**Subject:** San Mateo Park Elementary School HVAC Replacement  
San Mateo - Foster City School District  
Aedis Project No. 2021011.08  
DSA Application #01-120214

### ADDENDUM NO. 1

San Mateo Park Elementary School HVAC Replacement  
San Mateo – Foster City School District  
Aedis Project No. 2021011.08

**DEMOLITION FLOOR PLAN - BUILDING 1**

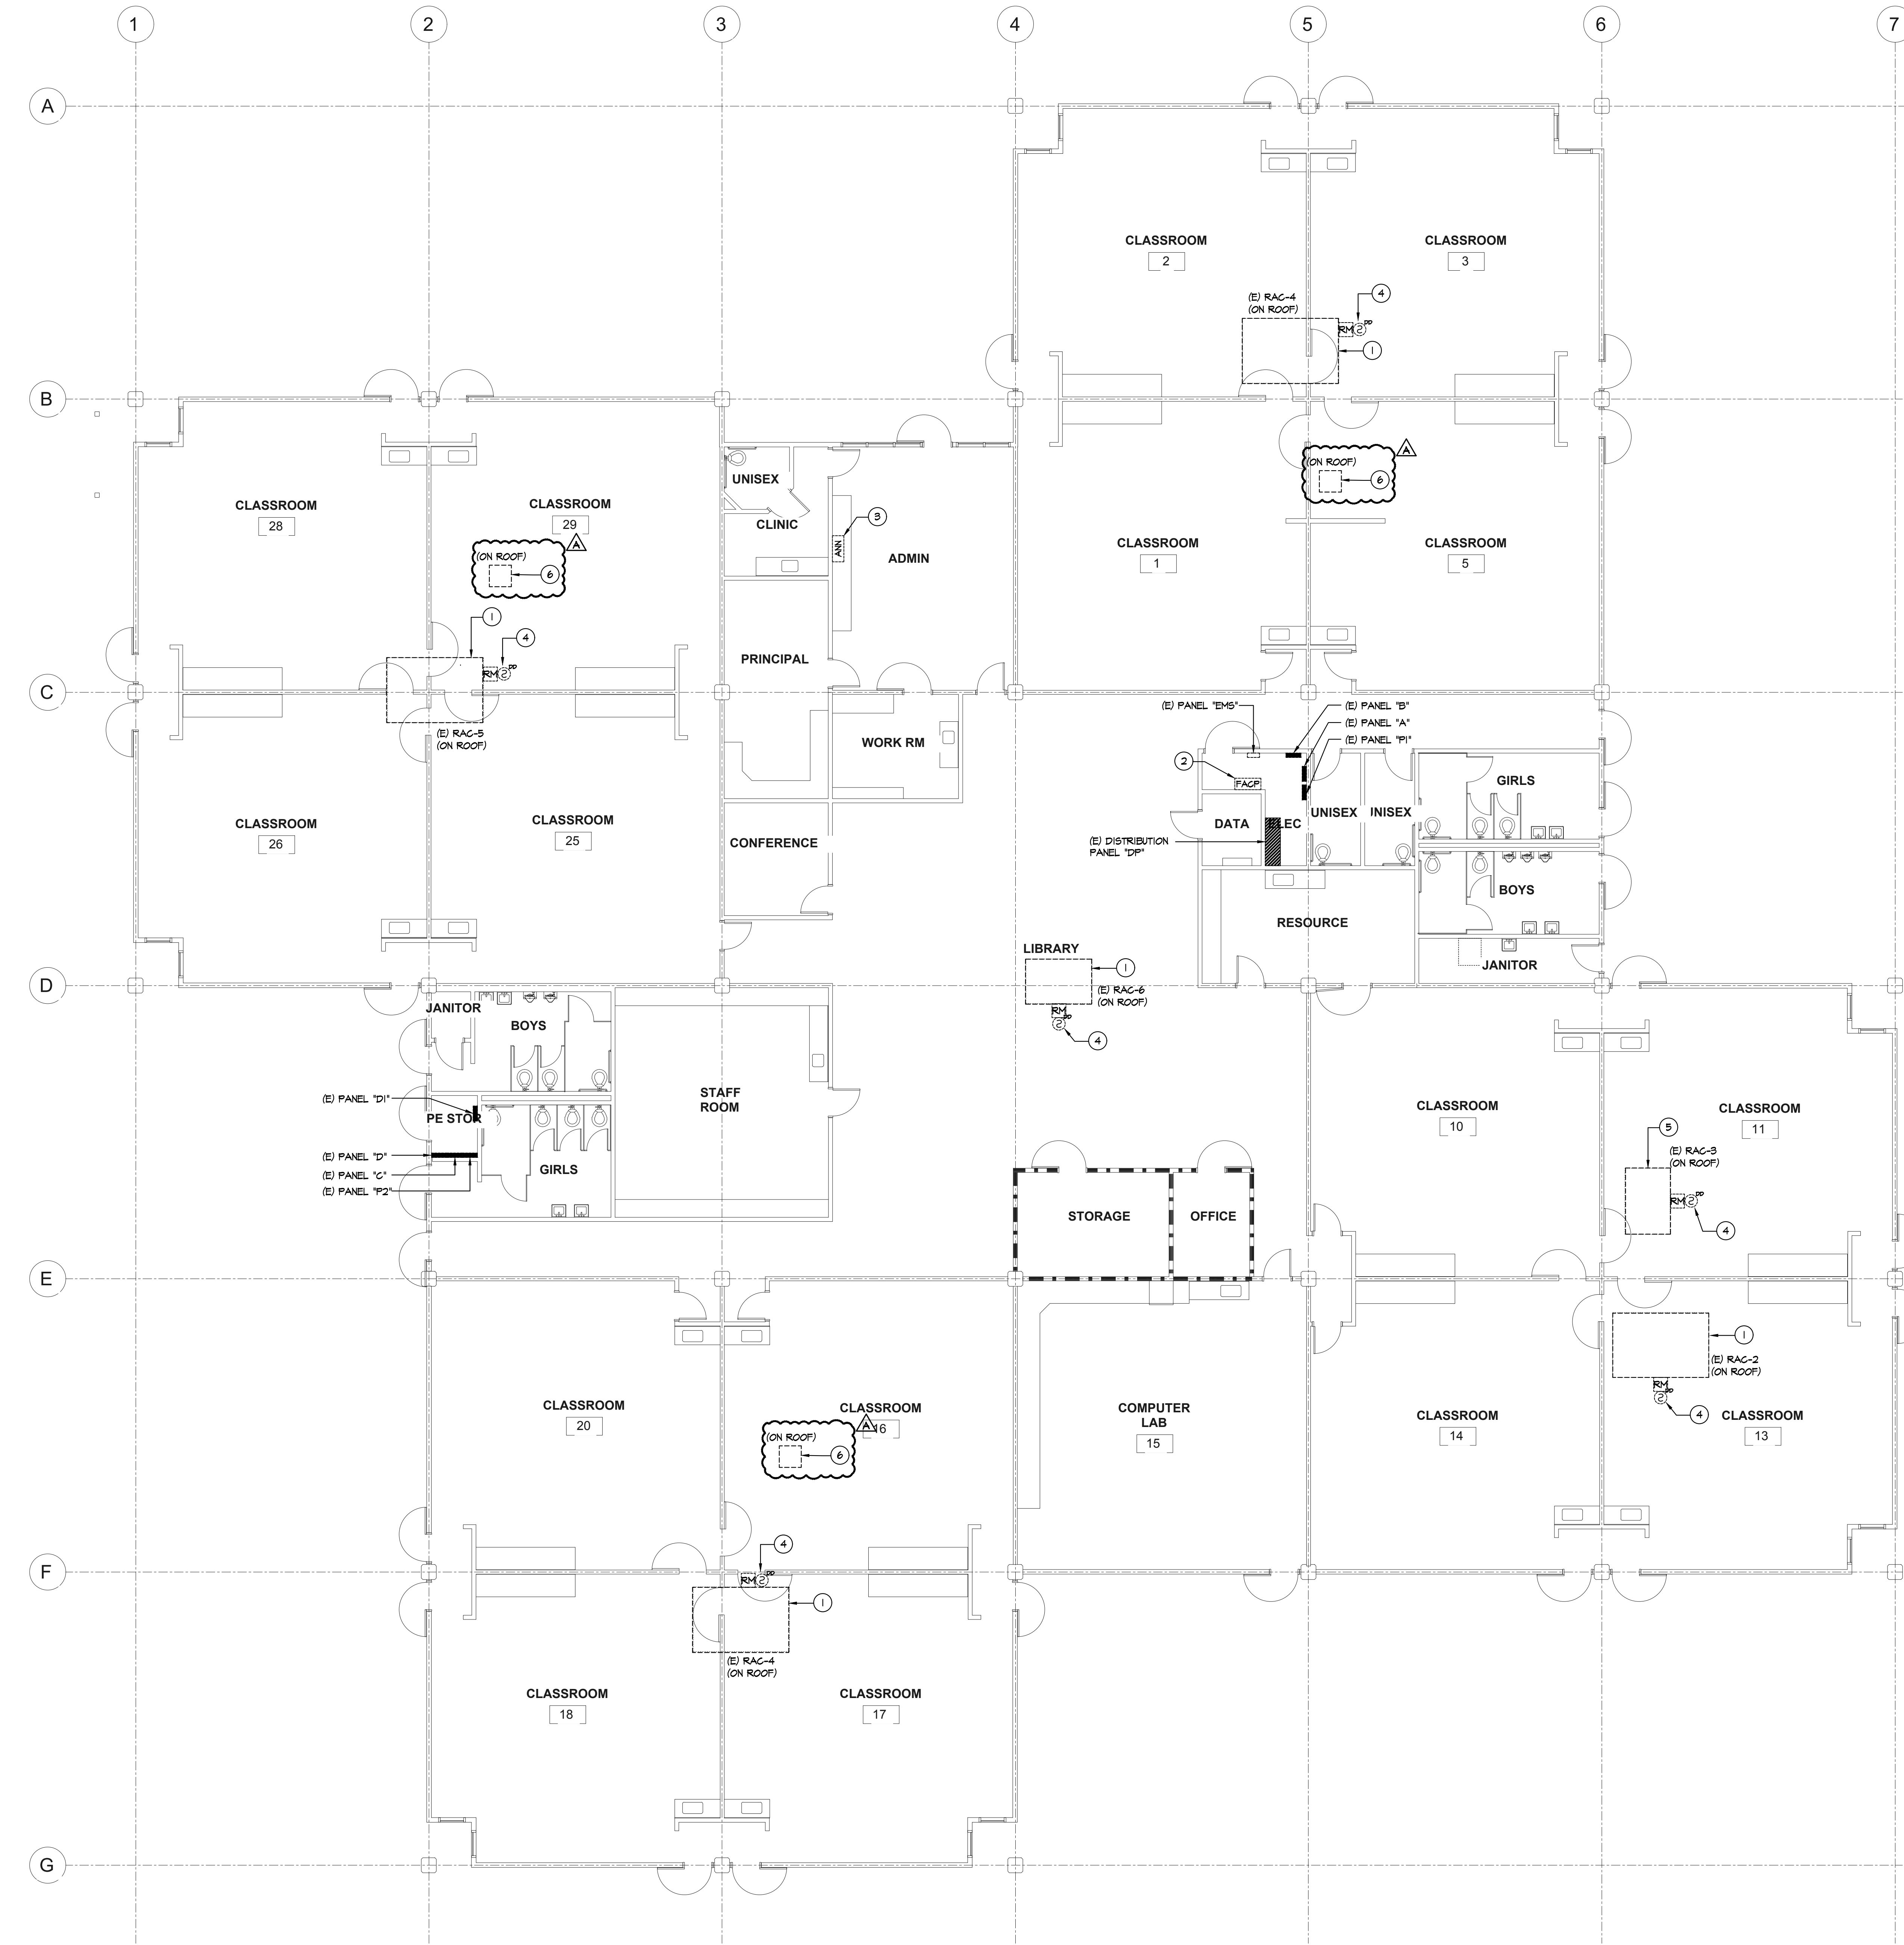
- Add: Existing rooftop exhaust fan demolition work and relocation per AD1-E2.1.
- Add: Demolition Sheet Note #6 and associated tags in plan per AD1-E2.1.

1 NEW FLOOR PLAN - BUILDING 1  
E3.1 SCALE: 1/8" = 1' - 0"

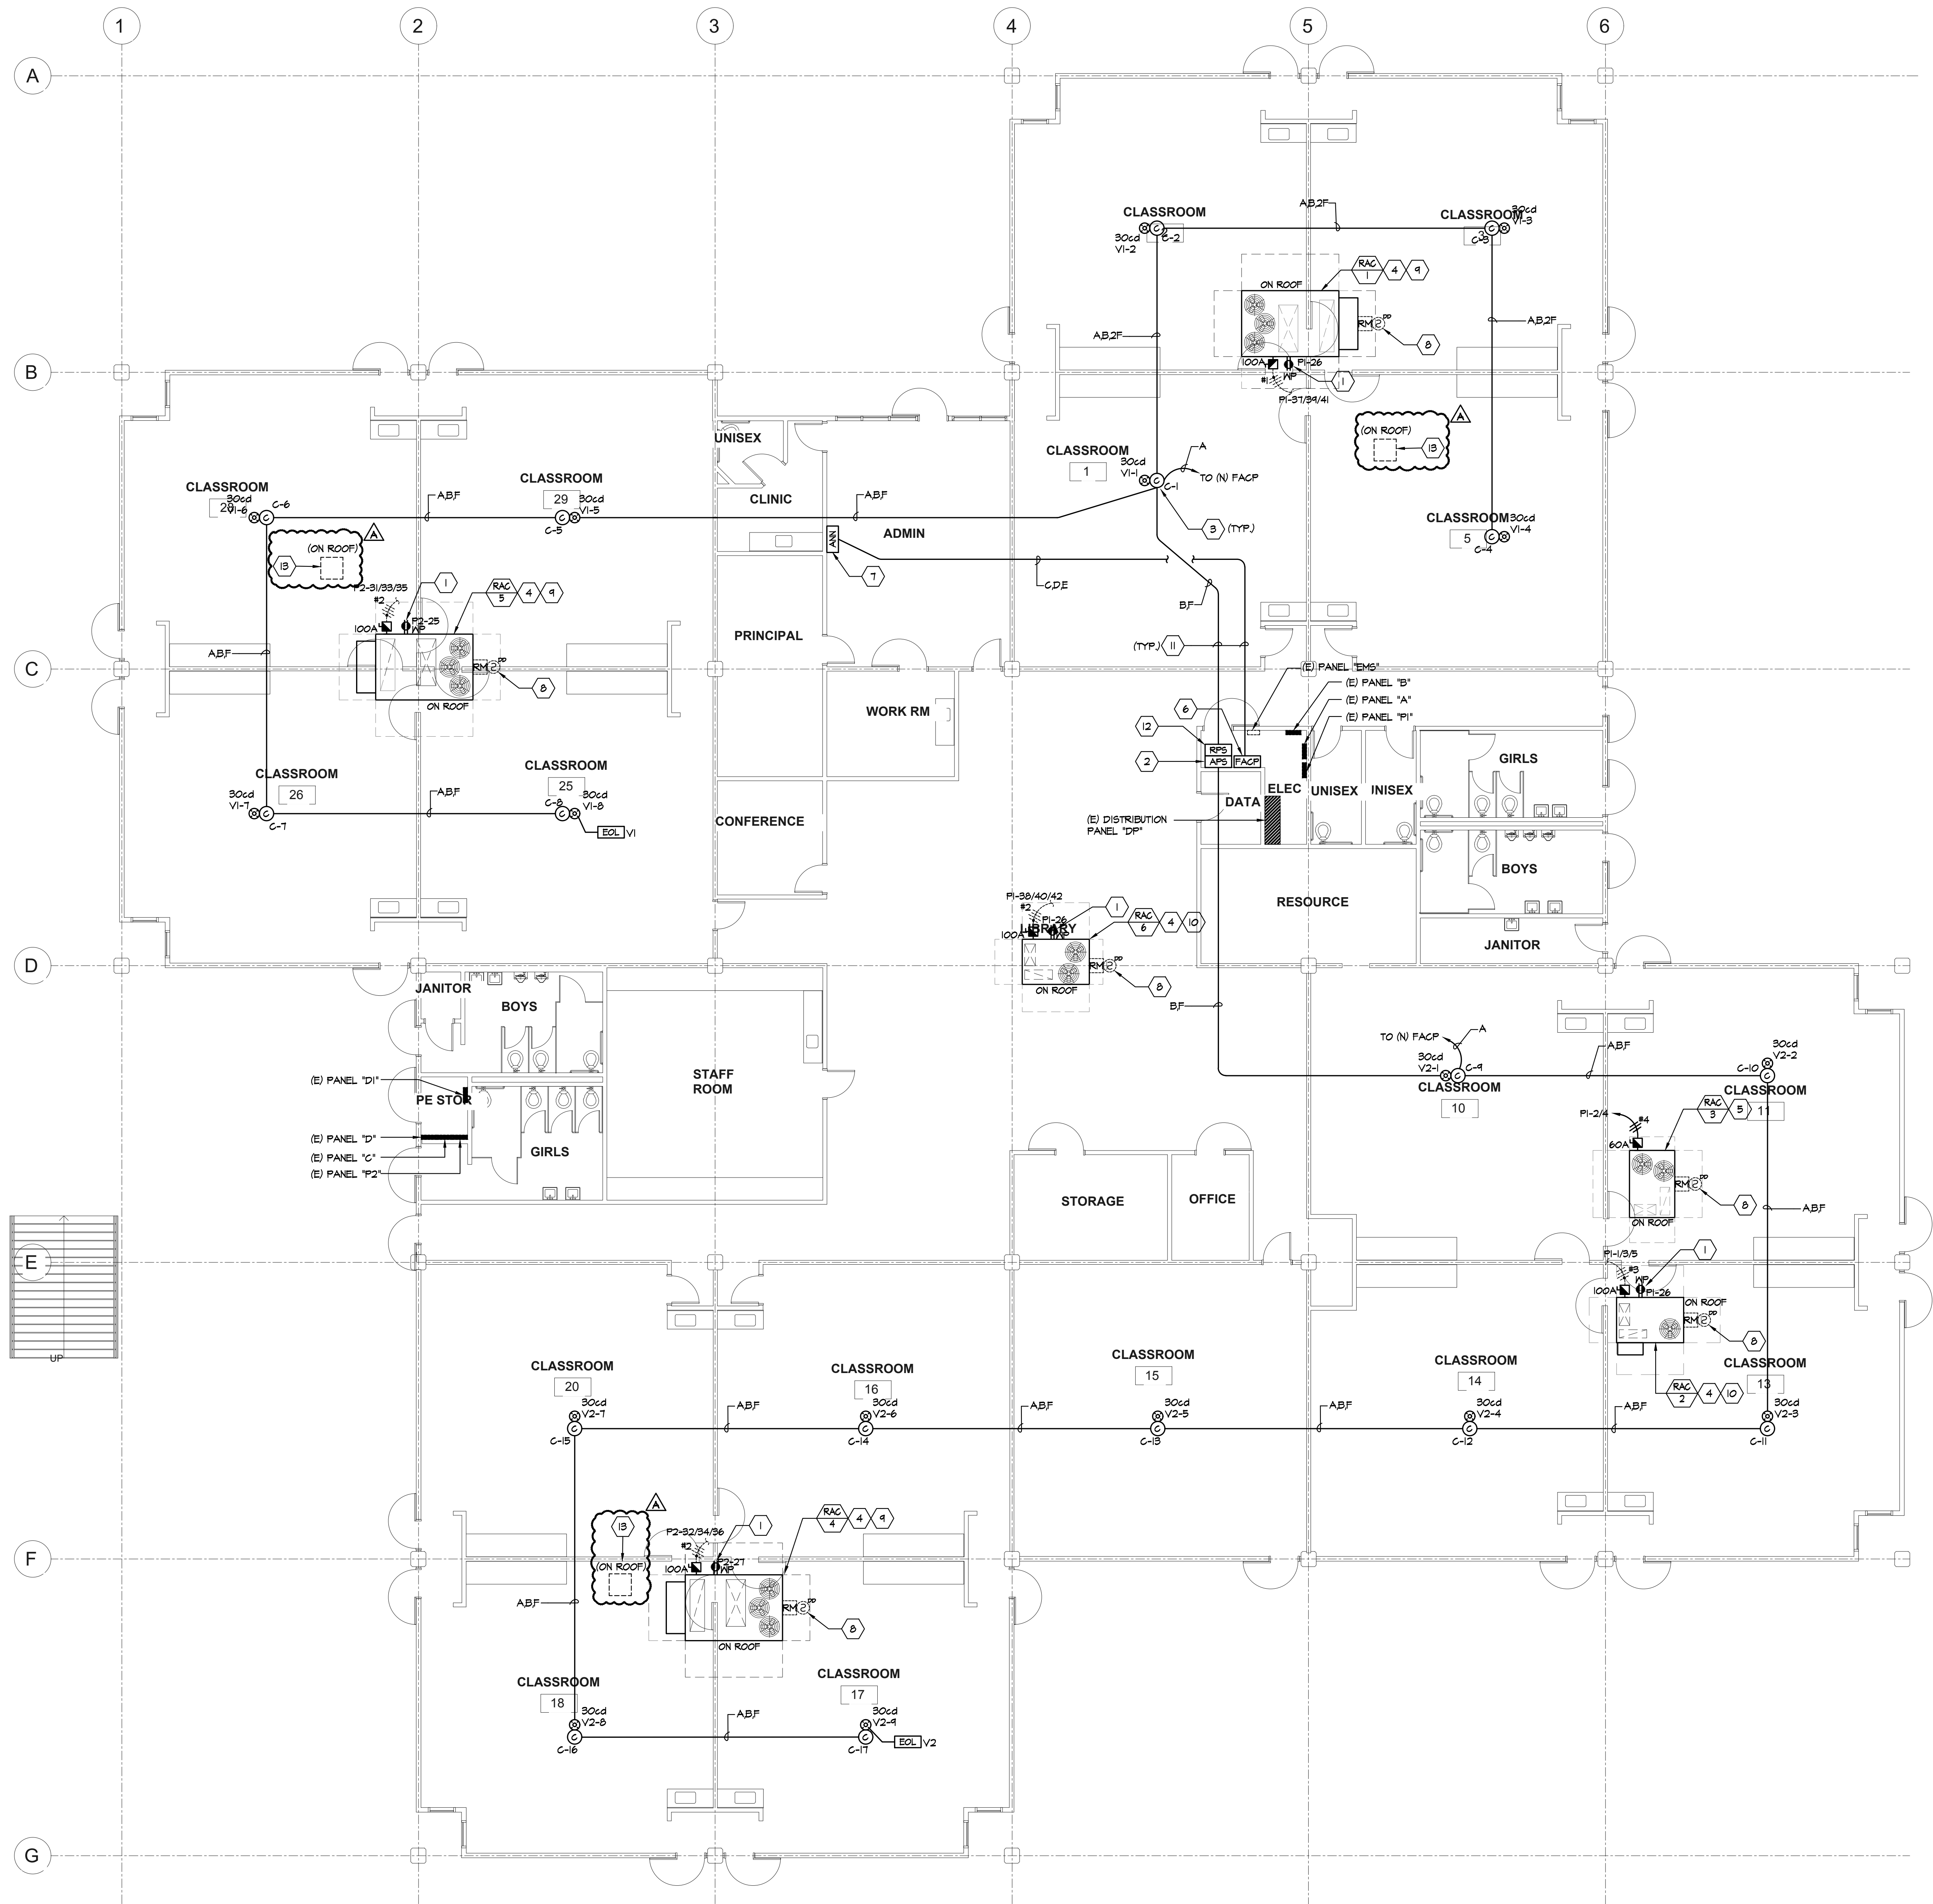
- Add: Existing rooftop exhaust fan relocation work per AD1-E3.1.
- Add: Sheet Note #13 and associated tags in plan per AD1-E3.1.

## DEMO SINGLE LINE DIAGRAM

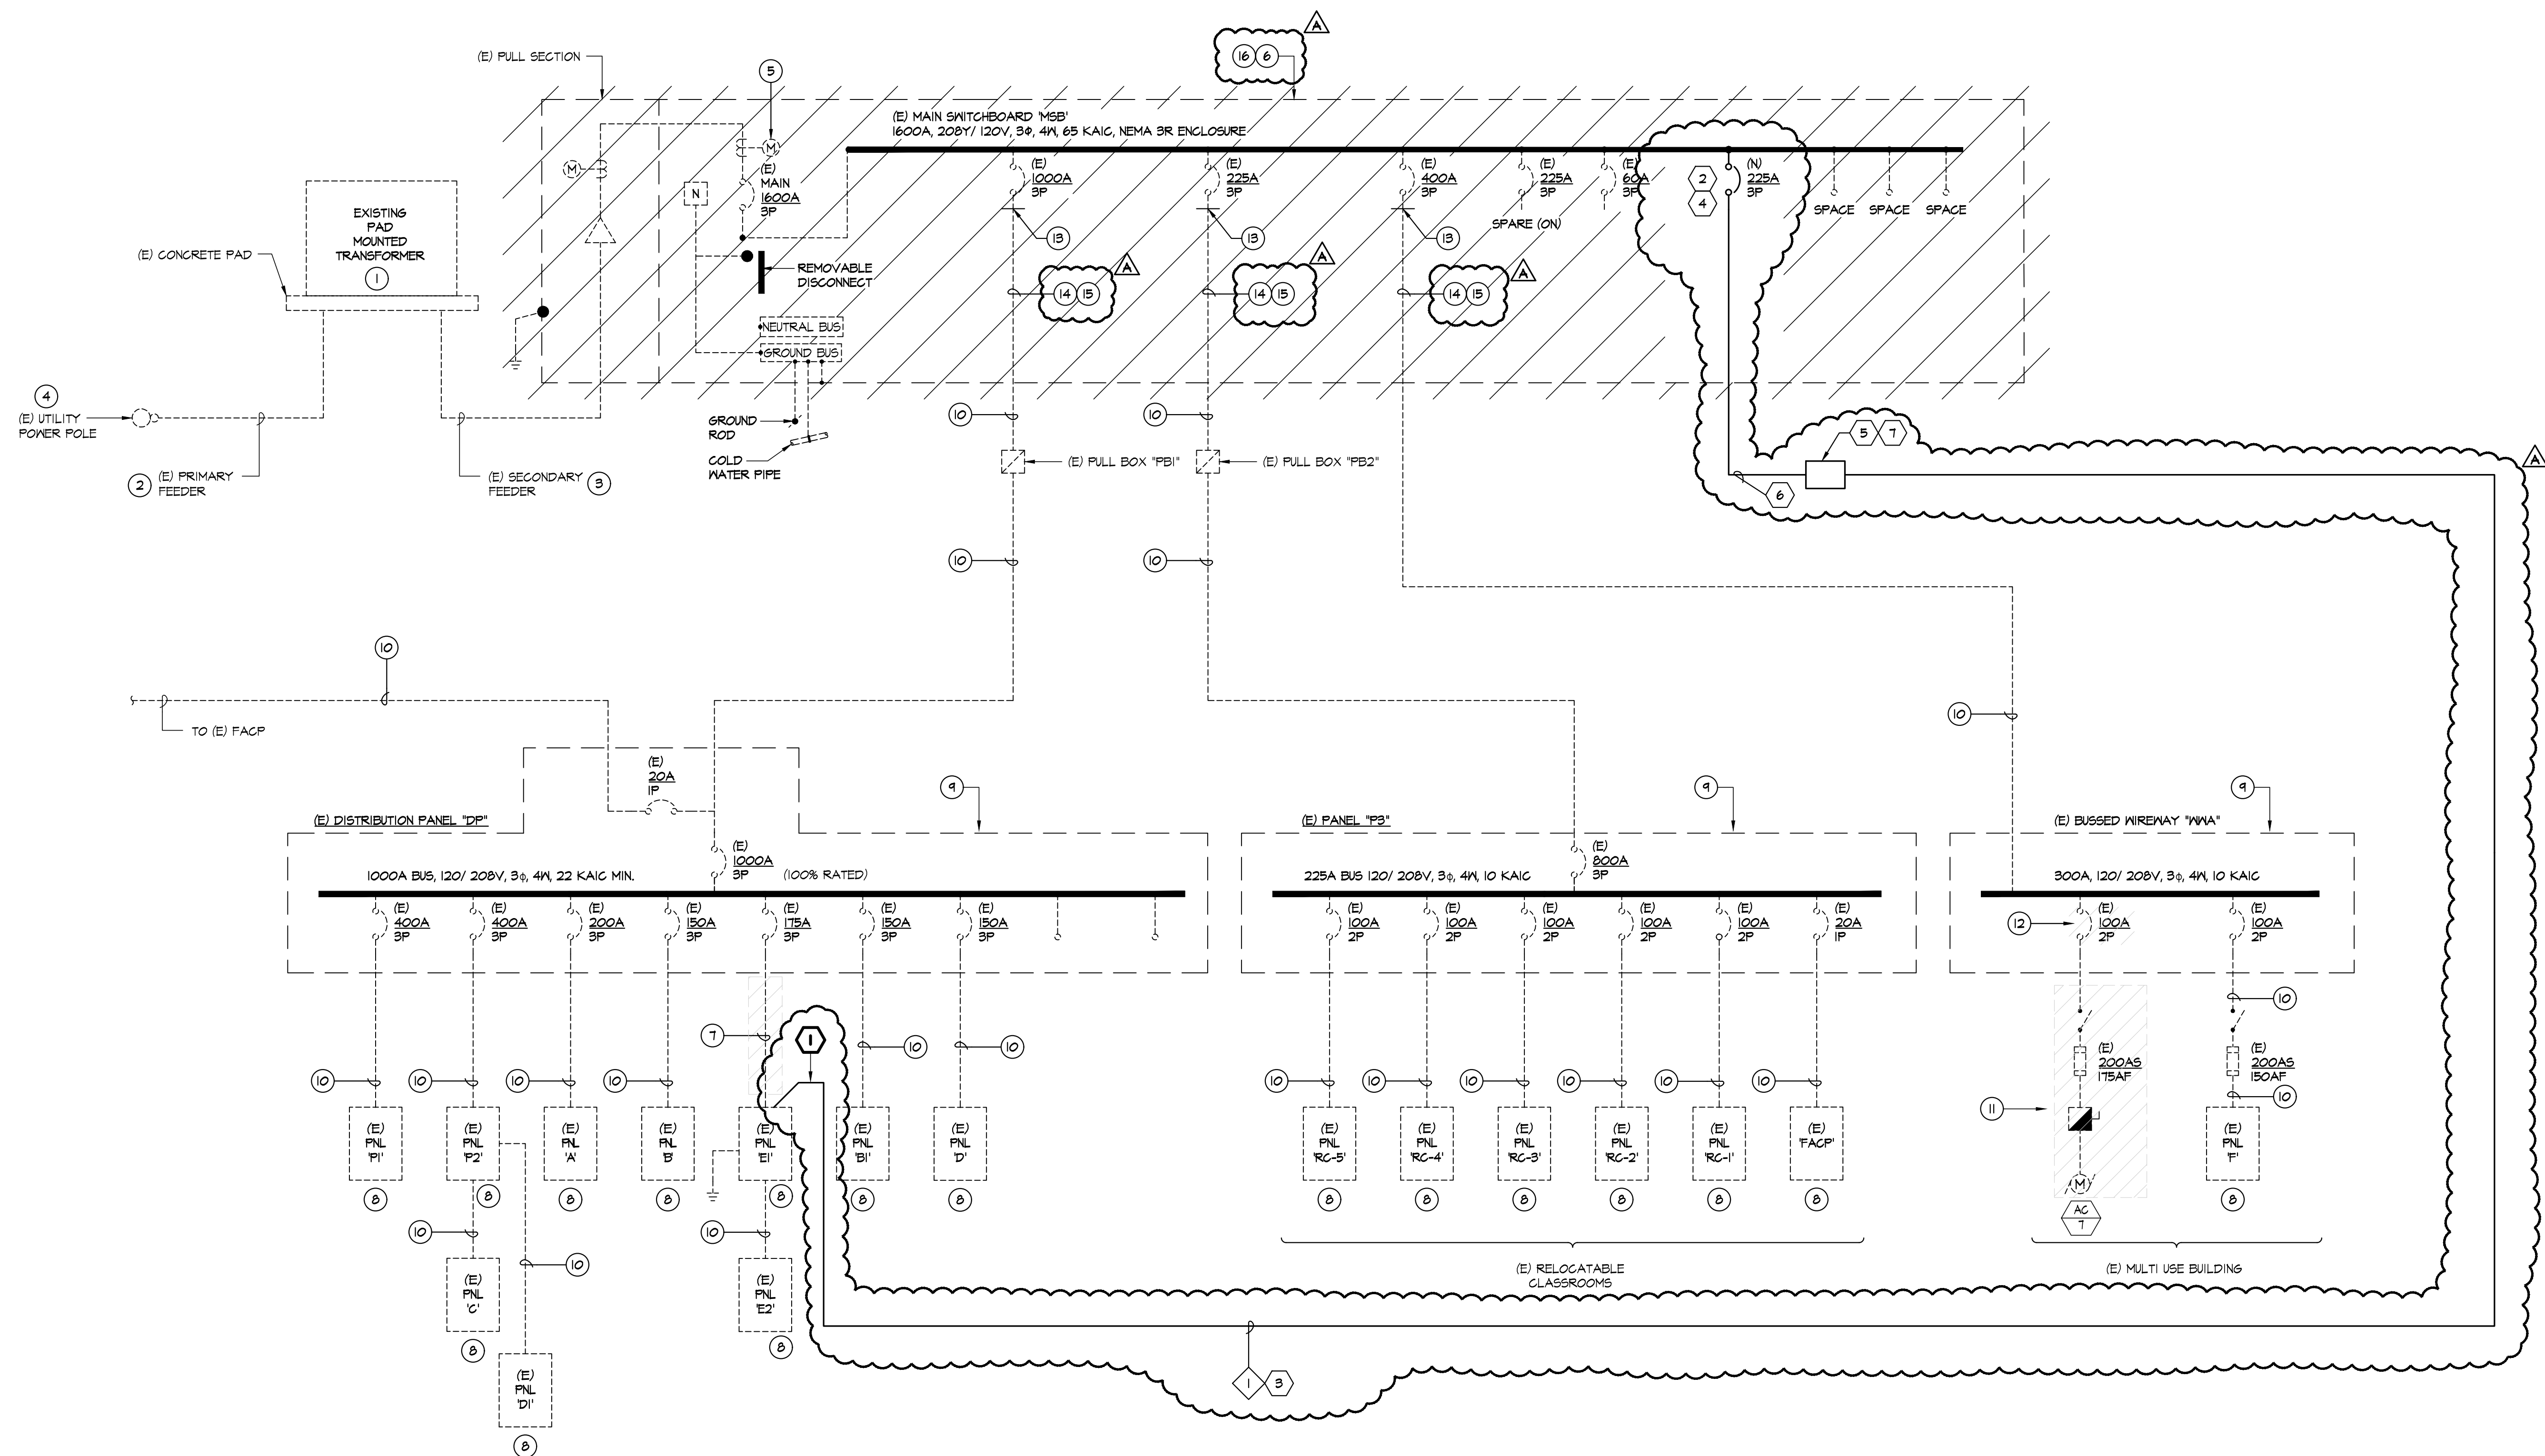
- Add: General Note #7 as shown per AD1-E4.1.
- Revise: Demo Single Line Diagram as shown per AD1-E4.1.
- Revise: Demolition Sheet Notes #13, #14 & #15 as shown per AD1-E4.1.
- Add: Demolition Sheet Note #16 and associated tag in Demo Single Line Diagram as shown per AD1-E4.1.
- Add: Sheet Notes #1 Thru #7 and associated tags in Demo Single Line Diagram as shown per AD1-E4.1.
- Add: Cable Schedule as shown per AD1-E4.1.
